MILITARY SPECIFICATION

MODULES, STANDARD ELECTRONIC

SHIFT REGISTER, DIGITAL, KEY CODE EML

This amendment forms a part of Military Specification MIL-M-28787/277(EC), dated 9 November 1983, and is approved for use by the Naval Electronic Systems Command, Department of the Navy, and is available for use by all Departments and Agencies of the Department of Defense.

FIGURE 11. Output voltage (low-level and high-level) test circuit for tables X and XI - Continued.

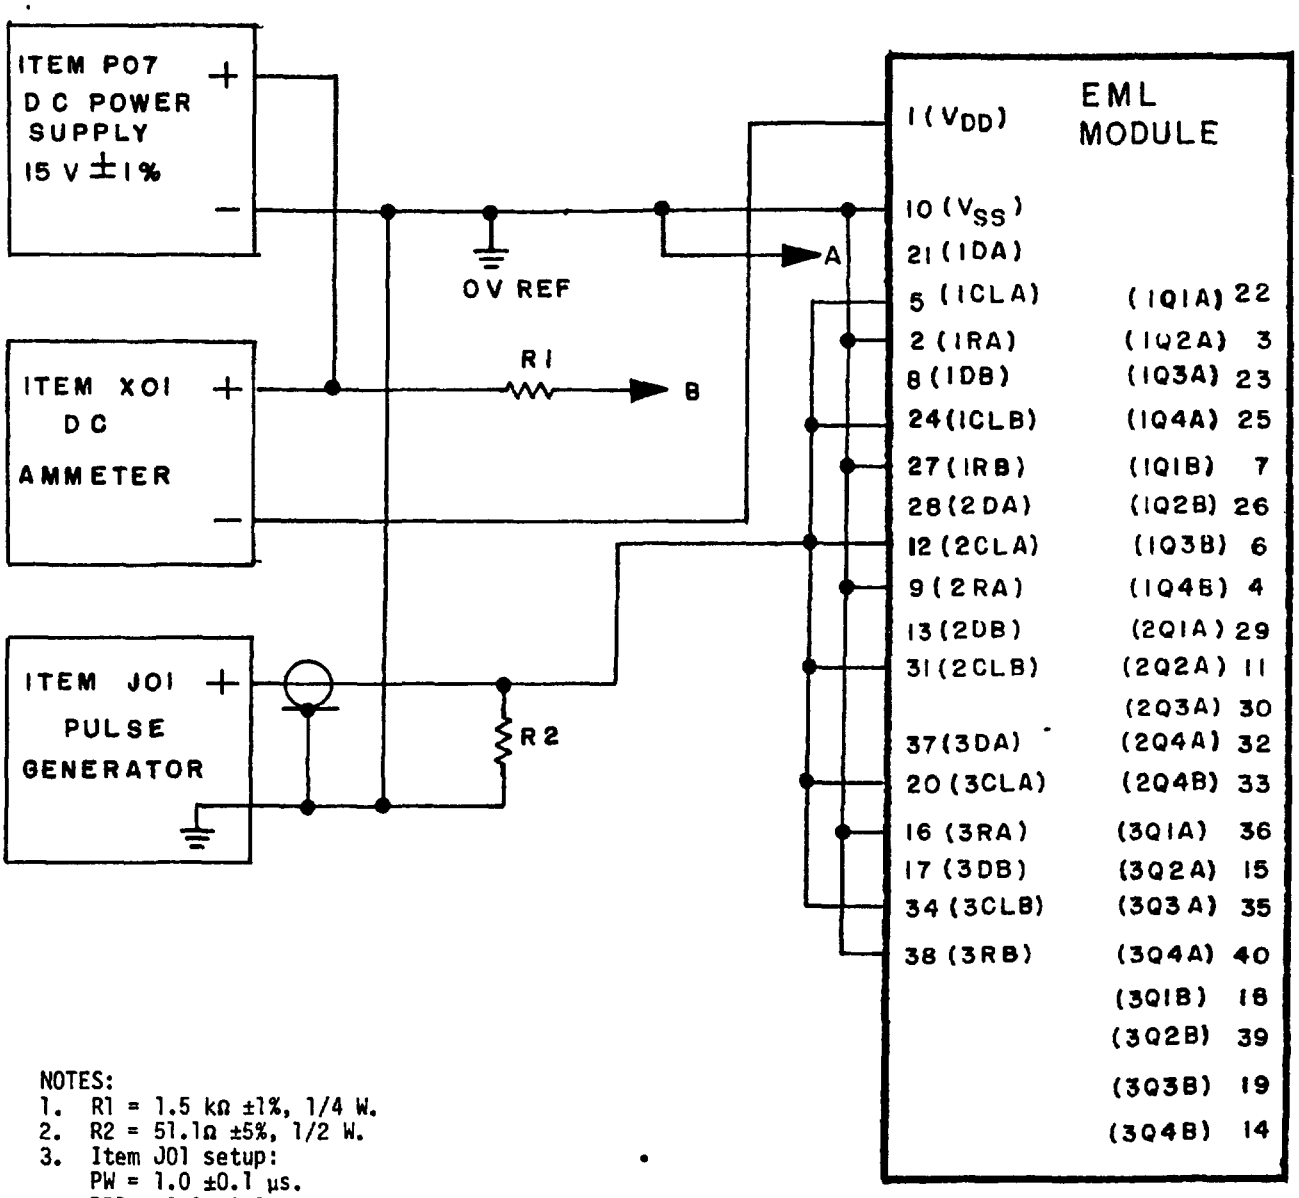
FIGURE 11: Delete and substitute new figure 11 as printed on page 2 of this amendment.

NOTES:
1. R1 = R2 = R5 = 51.1Ω ±5%, 1/8W.
2. R3 = R4 = 9.09 kΩ ±1%, 1/8 W at 0°C and 25°C.
   = 10.5 kΩ ±1%, 1/8 W at 60°C.
   = 11 kΩ ±1%, 1/8 W at 85°C.
   = 7.5 kΩ ±1%, 1/8 W at -55°C.
3. Item J01 setup.
   PA = 5 V ±1%.
   PW = 500 ±50 ns.
   PRP = 1,000 ±100 ns.
   $t_{TLH} = t_{THL}$ = 20 ±2 ns.
   Single pulse mode.
4. After establishing the setup input condition, apply four pulses using item J01.
5. After establishing the input conditions of test conditions F1 or G1, apply one pulse using item J01. Prior to making the specified measurement, repeat the sequence of notes for the remainder of the test.

FIGURE 15. Power supply current (low-level and high-level) test circuit for table XVI.

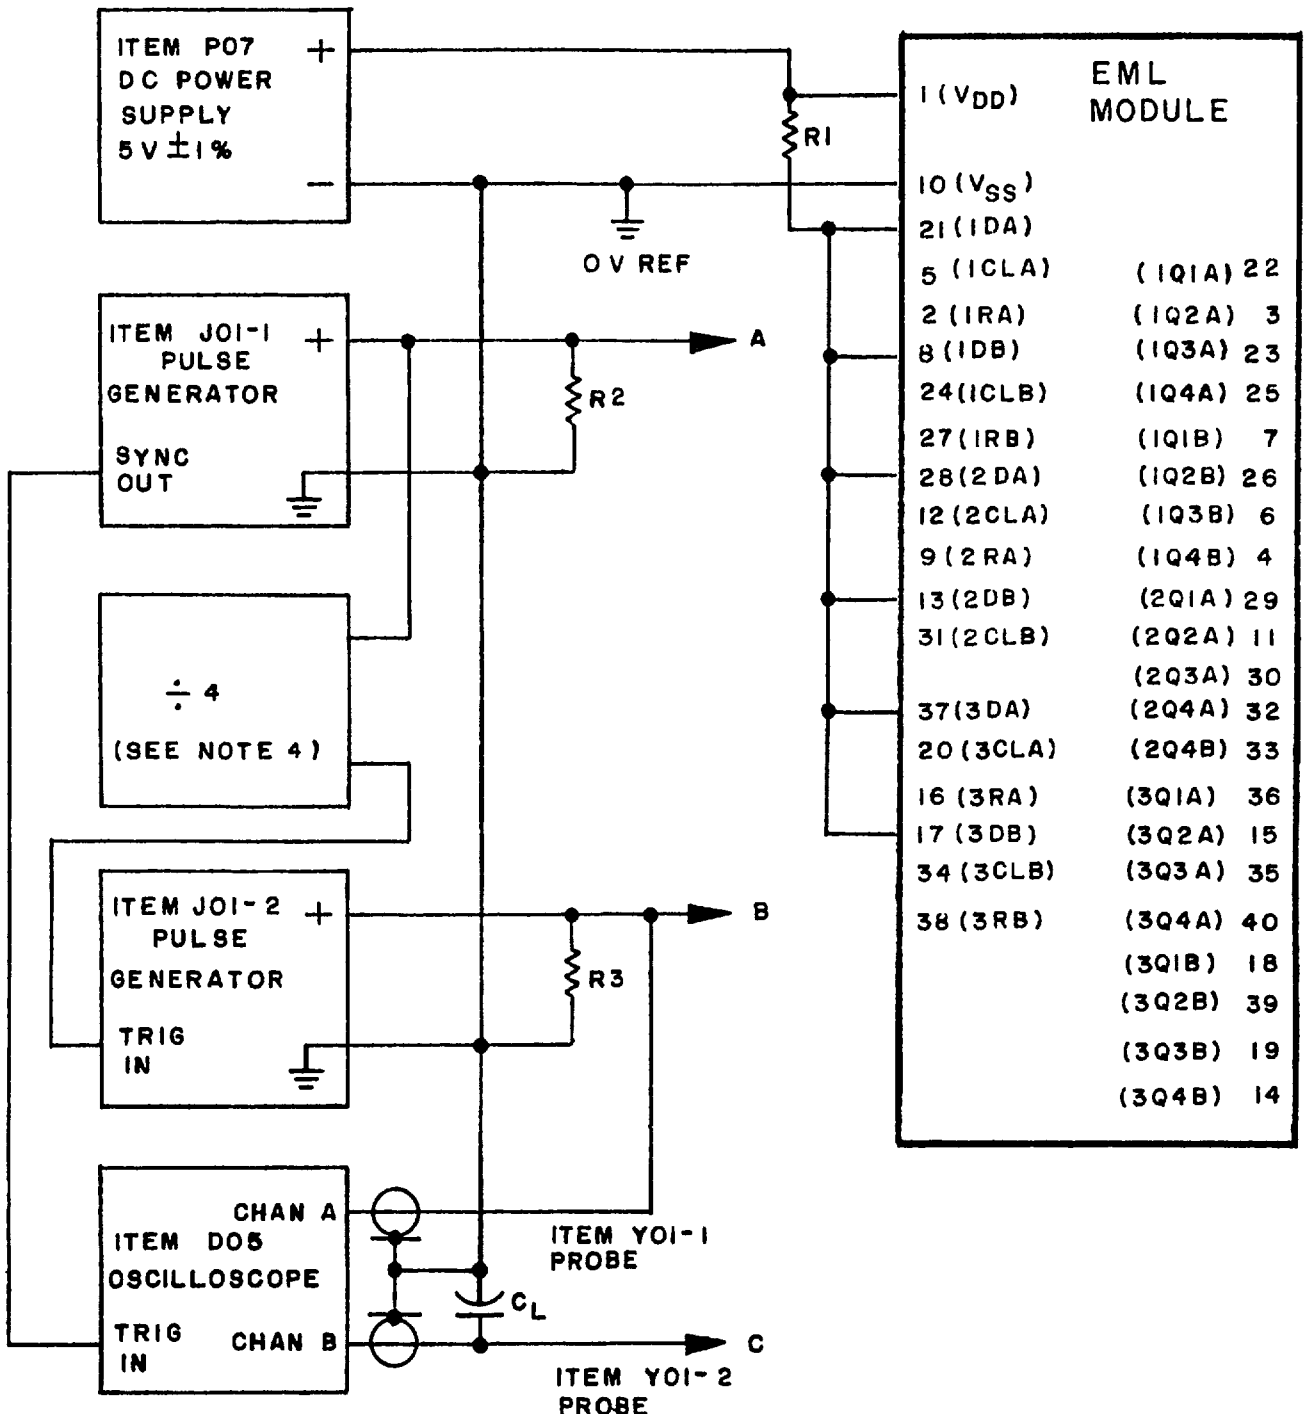
FIGURE 15: Delete and substitute new figure 15 as printed on page 3 of this amendment.

NOTES:
1. R1 = 1.5 kΩ ±1%, 1/4 W.
2. R2 = 51.1Ω ±5%, 1/2 W.
3. Item J01 setup:
   PW = 1.0 ±0.1 µs.
   PRP = 2.0 ±0.2 µs.
   PA = 15 V ±1%.
   $t_{TLH} = t_{THL}$ = 20 ±2 ns.
4. Put item J01 in single pulse mode after all connections are made. Pulse item J01 four times, measure test condition M1 and repeat procedure for test condition M2.

FIGURE 19. Propagation delay time (t_{PHL}) test circuit for table XXI.

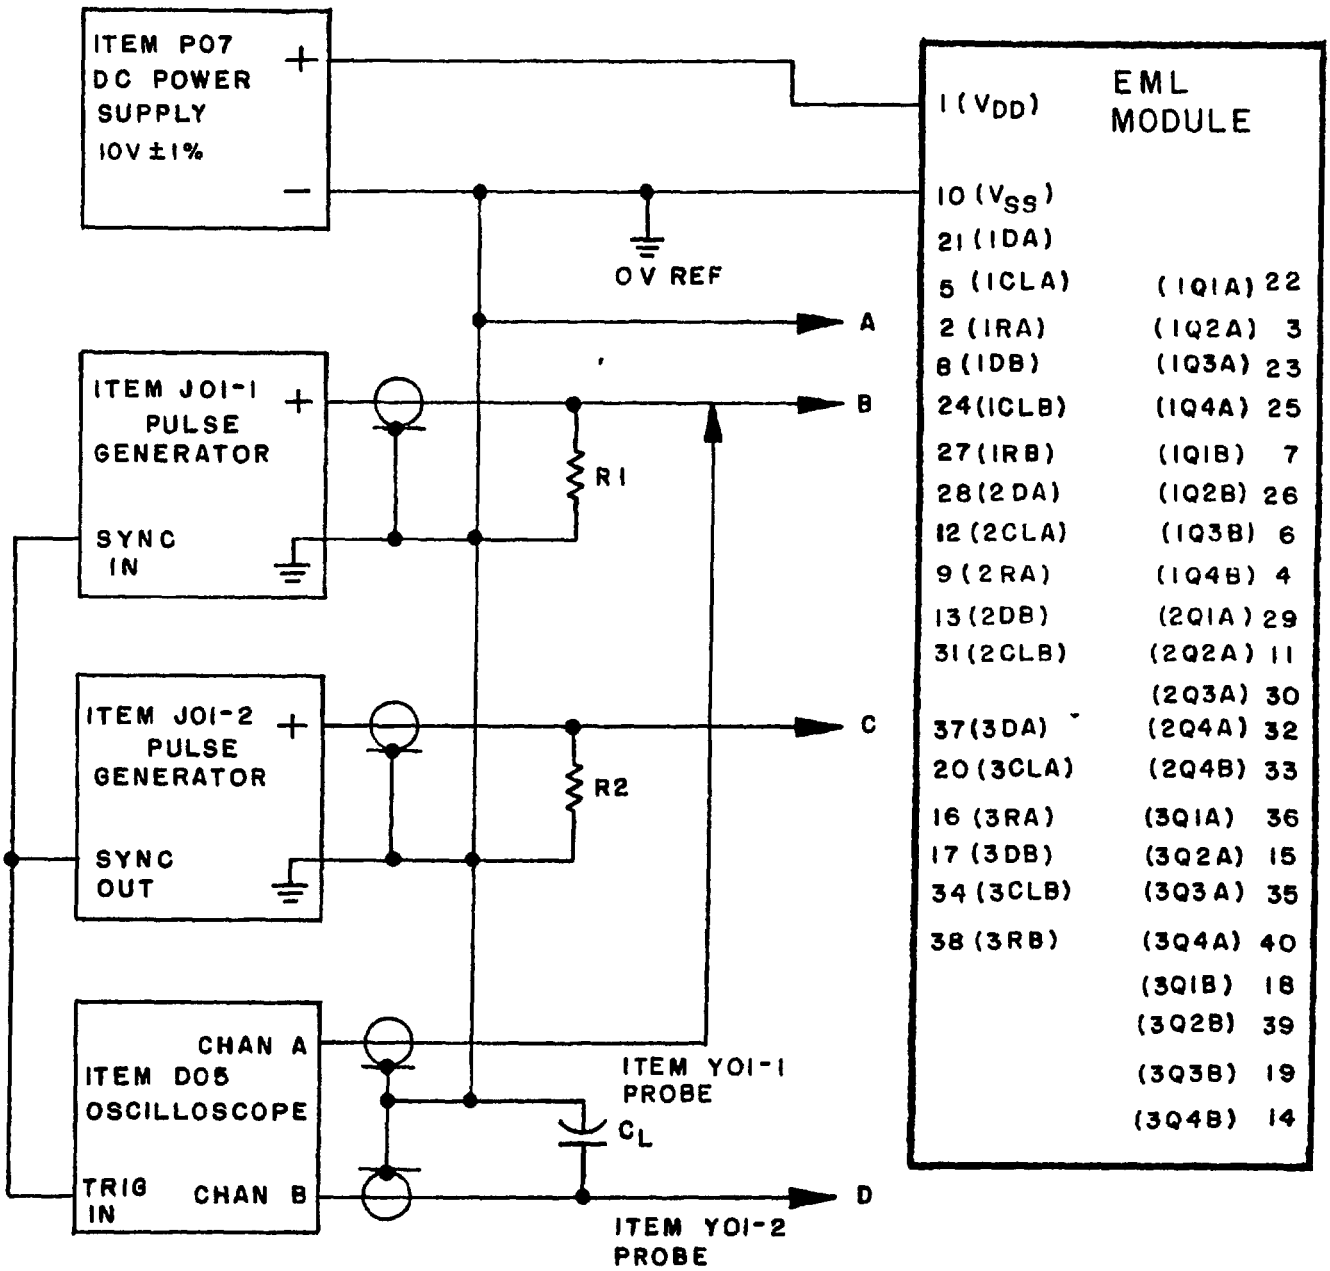
FIGURE 19: Delete and substitute new figure 19 as printed on page 4 of this amendment.

NOTES:
1. R1 = 1,000Ω ±5%, 1/4 W.
2. R2 = R3 = 50Ω ±5%, 1/2 W.
3. C_L = 50 ±5 pF for test conditions U1-U20.
   = 150 ±15 pF for test conditions U21-U40.
4. The divide by 4 function may be either a commercially available unit (such as the Tektronix Model 00501) or any circuit that will provide one trigger input to item J01-2 for every fourth output pulse of item J01-1.

FIGURE 21. Transition time (t_{TLH} and t_{THL}) and propagation delay time (t_{PLH} and t_{PHL}) test circuit for tables XXII through XXV.

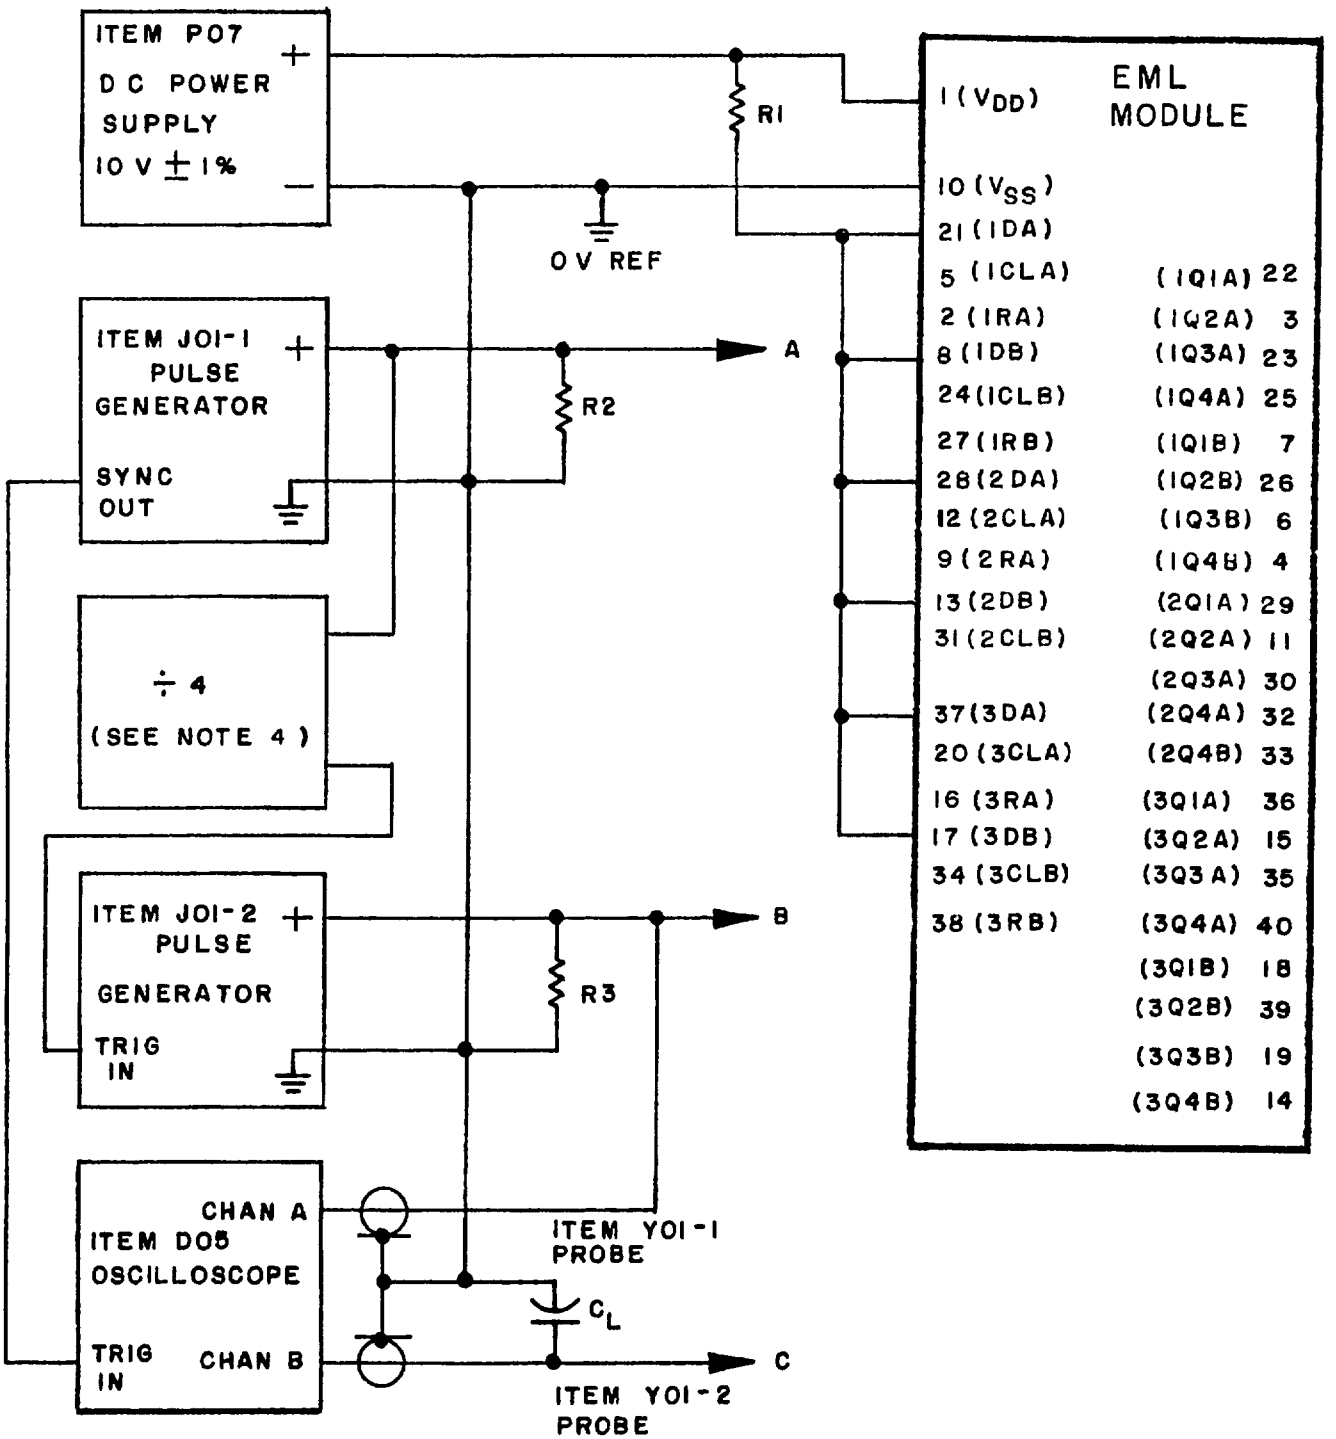
FIGURE 21: Delete and substitute new figure 21 as printed on page 5 of this amendment.

NOTES:
1. R1 = R2 = 51.1Ω ±5%, 1/2 W.
2. C_L = 50 ±5 pF (including probe and parasitic capacitance).
